Revised August 04, 2020 Per 1st VDOT Review – C.L. White

PLOT PLAN
FOR
PROPOSED RECHLORINATION FACILITY
SHOWING A NEW UTILITY BUILDING, UNDERGROUND VAULT, AND NEW PRIVATE ENTRANCE
FOR
THE WESTERN VIRGINIA WATER AUTHORITY
SITUATE THE SOUTHERN TERMINUS OF DUNAHOO DRIVE
CAVE SPRING MAGISTERIAL DISTRICT
COUNTY OF ROANOKE, VIRGINIA

NEW WATER INTERCONNECTION NOTES

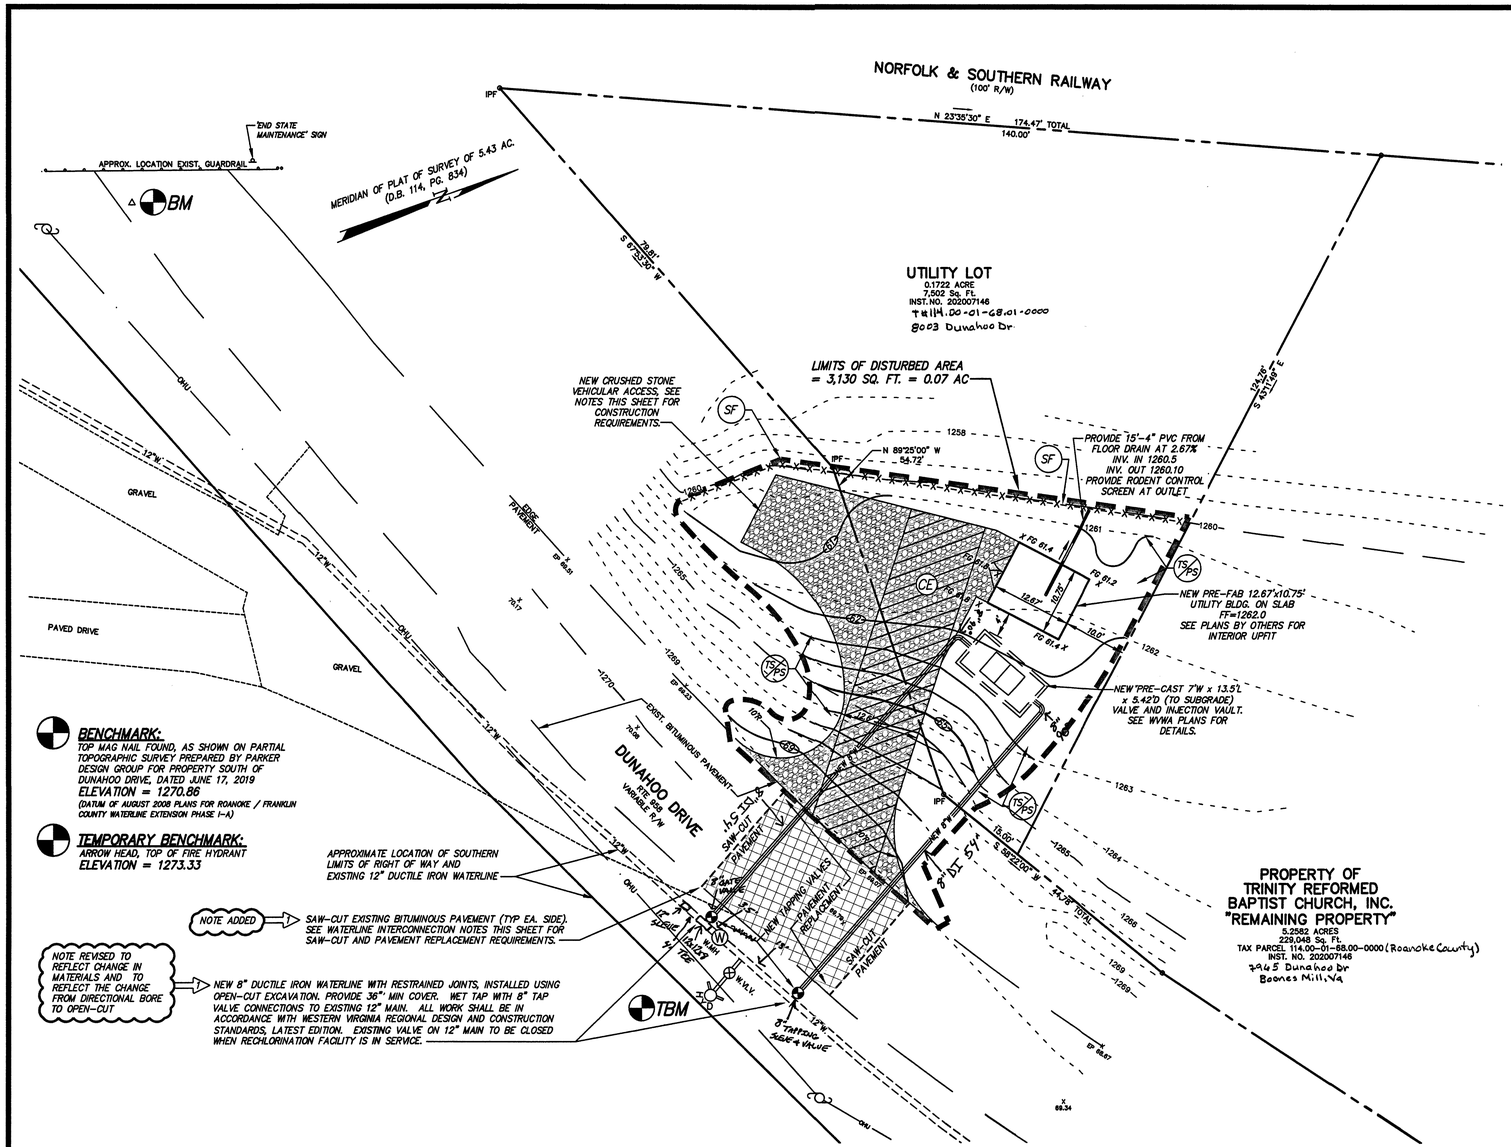
REVISED NOTES 2, 3, 4, & 6, AND DELETED ORIGINAL NOTE 3, TO REFLECT THE CHANGE FROM DIRECTIONAL BORE TO OPEN-CUT

1. THE LOCATION OF EXISTING WATER MAIN SHOWN HEREON IS BASED ON AVAILABLE RECORDS.
2. SEE ATTACHED TRAFFIC PLAN RELATIVE TO PAVEMENT OPEN-CUT AND WATERLINE INTERCONNECTIONS.

3. SAW-CUT EXISTING ASPHALT AT LOCATION OF EXCAVATION. THE SAW-CUT THROUGH BITUMINOUS MATERIAL SHALL BE ONE FOOT LARGER IN ALL DIRECTIONS THAN THE AREA OF BASE STONE REMOVAL, SUCH THAT REPLACEMENT BITUMINOUS MATERIAL WILL OVERLAP UNDISTURBED BASE STONE.

5. UPON COMPLETION OF THE NEW TAP, BACKFILL AND COMPACT THE EXCAVATION TO SUBGRADE, IN ACCORDANCE WITH WVWA AND VDOT REQUIREMENTS.
6. PROVIDE PAVEMENT REPLACEMENT IN ACCORDANCE WITH VDOT REQUIREMENTS.
